### **ADDENDUM No. 1**

Project Number: PW-10-14 **Bland Intertie Pump Station**  **Public Works Department**

Project Description:	Bland Intertie Pump Station
----------------------	-----------------------------

The following clarifications are applicable to drawings and specifications for the project referenced above.

SHEET: E-3

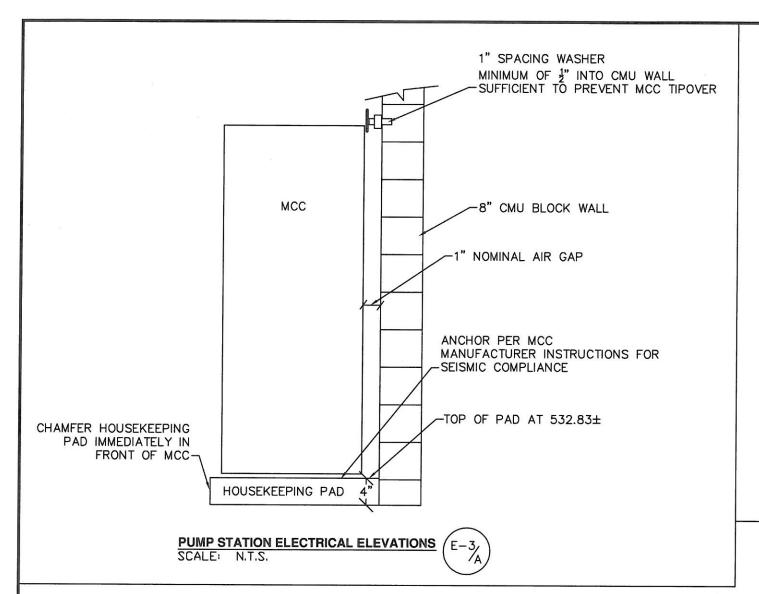
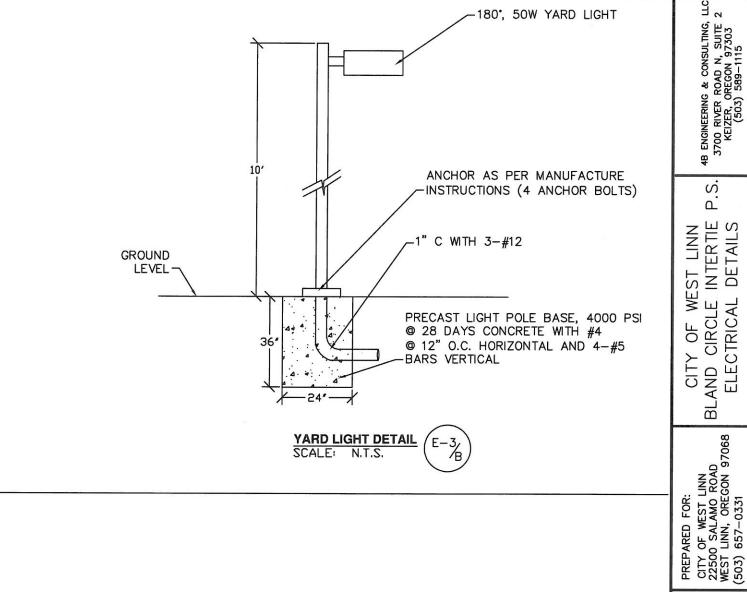
- 21) The 2" cleanout for the vault sump shall comply with City of West Linn Standard Construction detail WL-206.
- 22) The Contractor shall coordinate with the City and CenturyLink to intercept the existing phone service to the tank in a new telephone handhole and connect this handhole using a 2" PVC conduit into the pump station. Provide a 2'x2'x3/4" plywood telephone demarcation adjacent to the RTU for telephone service. Install a pull cord inside the 2" conduit for use by the phone company. Prepare for the telephone changeover immediately prior to pump station startup. Revise wire count shown on sheet E-3 for raceway number 1 from 4-#12, 2 pair Cat6 to 4-#12, 2 pair 16 GA. T&S.

- 23) To reroute the existing electrical service to the reservoir, the Contractor shall revise wire count shown on sheet E-3 and end point location for raceway number 2. Revise origin from RTU to MCC SEC 5, revise wire from spare to 5-#12. Supply terminal junction box and GFCI WP 120V outlet with cover. Terminate raceway number 2 at new terminal junction box and locate below existing cathodic protection unit. Route one circuit to cathodic protection and second circuit to outlets. Route GFCI protected wires from outlet to reservoir level enclosure immediately adjacent to cathodic protection unit for heat lamp use.

RACEWAY NUMBER	DRIGIN	DESTINATION (	CONDUIT SIZE	NO. & SIZE OF CONDUCTORS	LOAD DESCRIPTION
1	RTU	RESERVOIR		4-#12, 2 PAIR 16 GA. T&S	RESERVOIR OVERFLOW, HATCH LEVEL
2	MCC SEC. 5 (PB)	NEW TERMINAL JUNCTION BOX )	3/4"		POWER FOR CATHODIC PROTECTION/OUTLET
3	KIO	FROM DOOR INTRUSION	1/2"	1 PAIR 16 GA. T&S	TOTRUSTEN ALARM
4	RTU	LOUVER 1	1/2"	3-#12	LOUVER POWER AND CONTROL
5	MCC SEC. 7 (CB)	JUNCTION BOX (UH)	1/2"	4-#12	HEATER POWER
6	UH	RTU	1/2"	3-#12	HEATING CONTROL
7	RTU	SMOKE ALARM	1/2"	3-#12	SMOKE ALARM
8	RTU	FIT-962 (FLOWMETER XMTR)	1/2"	1 PAIR 16 GA. T&S	DISCHARGE PRESSURE
9	MCC SEC 5 (PB)	JUNCTION BOX AT FRONT DOOR	1/2"	3-#12	LIGHTING SWITCH AND FRONT DOOR OUTLET
10	MCC SEC 5 (PB)	RTU	1/2"	5-#12	RTU POWER
11	RTU	FAN	1/2"	3-#12	FAN POWER AND CONTROL
12	MCC SEC 5 (PB)	SITE LIGHTING	1"	3-#12	SITE LIGHTING
13	GENERATOR RECPT.	MCC SECTION 7	2-1/2"	3-3/0, 1-#4 GRD, 1-#1 NEU	
14	MCC SEC 5 (PB)	DUTLETS	1/2"	3-#12	DUTLET POWER

### BOLLARD DETAIL FOR ELECTRICAL TRANSFORMER

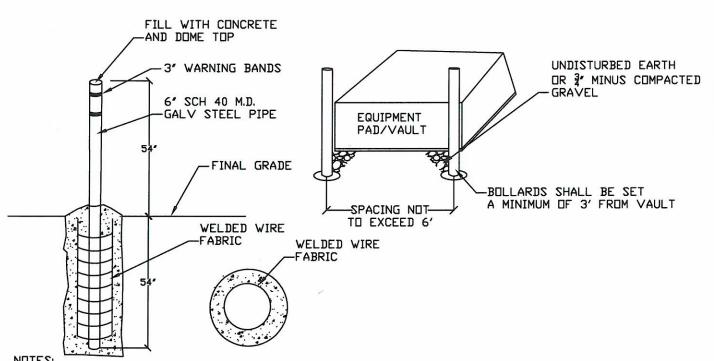
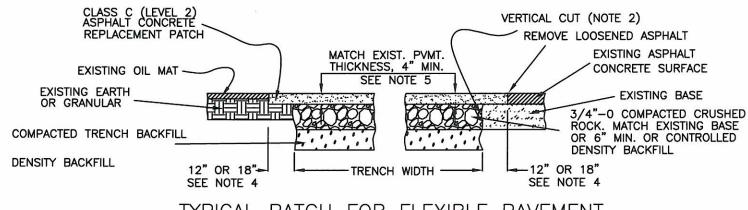
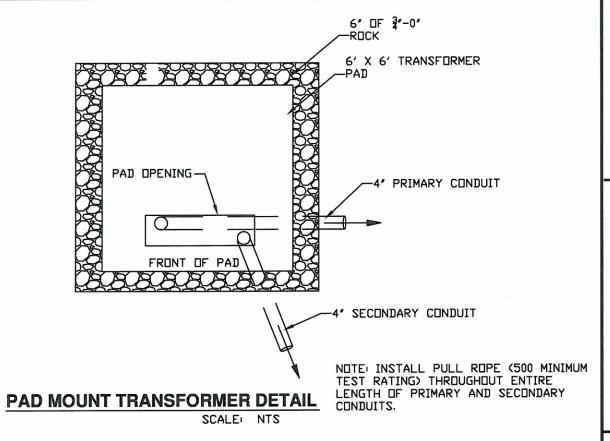
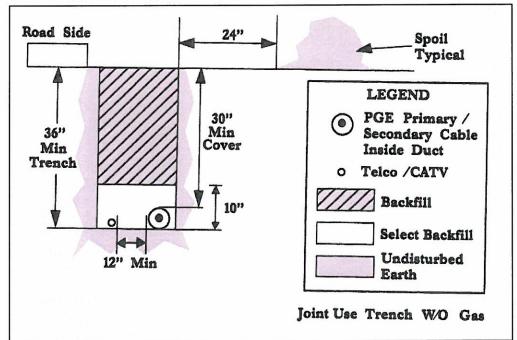
- 4) The drain line connection shall be made using an 8" x 2" saddle to the existing drain line.
- 5) The electrical service shall be brought into the site and to the pump station as detailed on the revised and attached drawings for both primary and secondary power circuits.
